St. Johns River

Water Management District

DATE: June 27, 2018
TO: Prospective Respondents
FROM: Amy Lucey, Contracts Administrator
SUBJECT: Addendum #1 to Invitation for Bids # 33203, 96B Rehabilitation

96B Approach Slab Detail

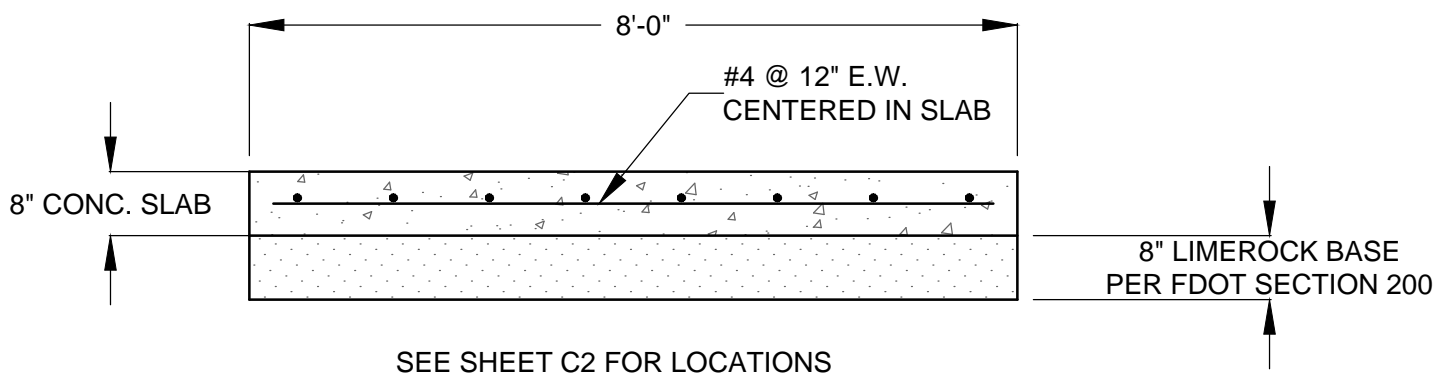
- Page 53, Statement of Work, Task Identification, shall add the following paragraph:
36. Concrete Bridge Approach Slabs
Construct cast-in-place reinforced concrete approach slabs as detailed on the drawings.
